Access Compliance Report
Public Rights-of-Way
(Curb Ramps)

Intersection ID: 23833	**Main Street: FOXRIDGE_RD**	**Cross Street: MCALPINE_FARM_RD**	**Location: SW**
ADA ID: D675D7614111	**Ramp Type: PerpDiag**	**Initial Pass/Fail: Fail**	**Overall Compliance: No** / **Severity Score: 25**

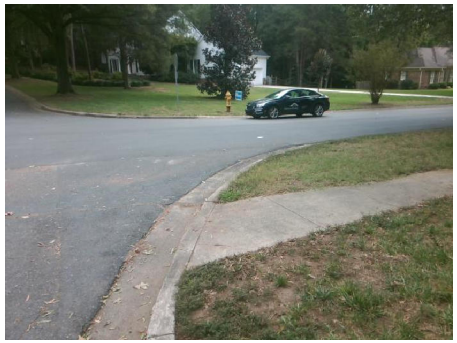
Compliance	Description	Data	Compliance	Description	Data
N/A	Ramp Length (in)	54.0	No	Ramp Slope (%)	8.5
Yes	Ramp Width (in)	48.0	No	Ramp XSlope (%)	5.9
N/A	Flare Type LT	N/A	N/A	Flare Type RT	N/A
N/A	Flare Slope LT (%)	N/A	N/A	Flare Slope RT (%)	N/A
N/A	Flare Traversable LT?	N/A	N/A	Flare Traversable RT?	N/A
N/A	Landing Length (in)	N/A	N/A	DWS Provided?	N/A
N/A	Landing Width (in)	N/A	N/A	DWS Contrast?	N/A
N/A	Landing Slope (%)	N/A	N/A	DWS Length (in)	N/A
N/A	Landing X Slope (%)	N/A	N/A	DWS Full Width?	N/A
N/A	Landing Curb? (Y/N)	N/A	N/A	DWS Offset (in)	N/A
N/A	Shared Landing?	N/A			
N/A	Gutter Ponding?	N/A	N/A	Gutter Slope (%)	N/A
N/A	Gutter Lip Ht (in)	N/A	N/A	Gutter X Slope (%)	N/A
N/A	Painted X Walk1?	No	N/A	Painted X Walk2?	No
	X Walk 1 Direction	To E		X Walk 2 Direction	To N
N/A	X Walk 1 Width (in)	N/A	N/A	X Walk 2 Width (in)	N/A
	X Walk 1 Slope (%)	0.5		X Walk 2 Slope (%)	7.3

X Walk 1 X Slope (%)	5.1		X Walk 2 X Slope (%)	1.8
N/A	Ramp inside XWalk1?	N/A	N/A	Ramp inside XWalk2?	N/A
	Road Slope (%)	4.3	N/A	Clear Space?	N/A
	Road X Slope (%)	4.7	N/A	Clear Space to XWalk (in)	N/A
N/A	Any Obstructions?	N/A	N/A	Storm Grate/Utility Hazard?	N/A
	Obstruction Type			Storm Grate/Utility Type	
		N/A			N/A
			Yes	Surface Condition? (G/P)	Good

Remove & Replace Curb Ramp With Two New Directional Ramps or Equivalent.
